Docket Item # 5
BAR CASE #2010-0119

BAR Meeting
June 16, 2010

ISSUE: Alterations
APPLICANT: Old Town Windows and Doors for Todd Hollis
LOCATION: 724 Gibbon Street
ZONE: RB/Residential

The applicant is requesting approval of a Certificate of Appropriateness for replacement windows at 724 Gibbon Street.

Figure 5: Specifications sheet of proposed replacement windows

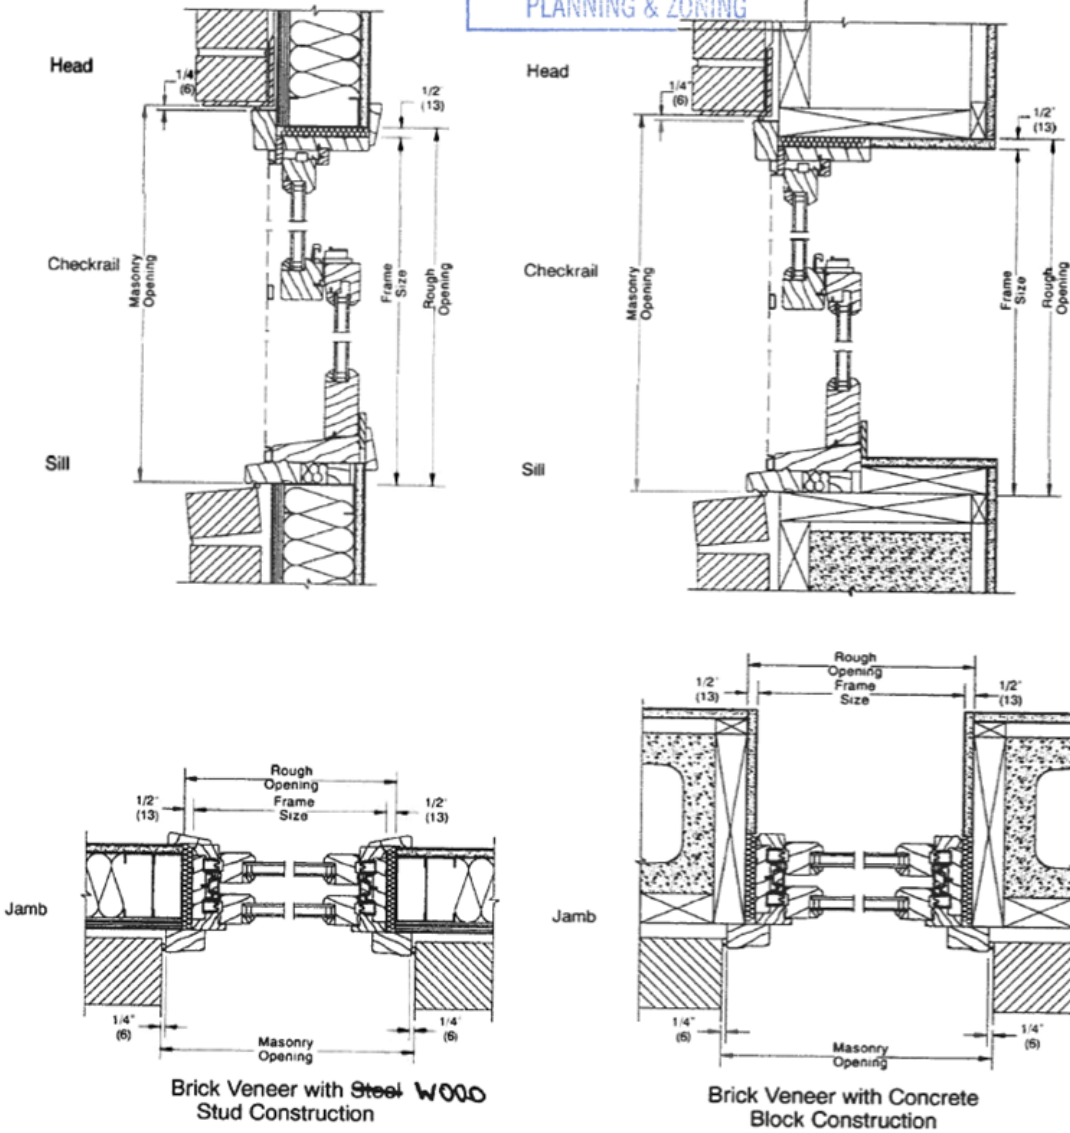
In this particular case, Staff believes that double glazed windows, which were commercially available when this townhouse was constructed in 1979, are appropriate replacement windows and significantly more attractive than the existing single glazed windows covered by aluminum storm panels. Staff further believes that the appearance of modern simulated divided light windows is indistinguishable from true divided light sash and allows the profile of the muntins to be thinner and more historically accurate.

Therefore, given the age of the townhouse and the fact that the existing 6/6 and 9/9 light pattern and putty glazed muntin profile and size will be retained, Staff does not object to the installation of painted wood double-insulated windows, with simulated divided light, and dark colored interior spacer bars. Staff finds the proposed replacement windows appropriate and compatible with nearby buildings of historic merit.

Staff recommends approval of the application as submitted.
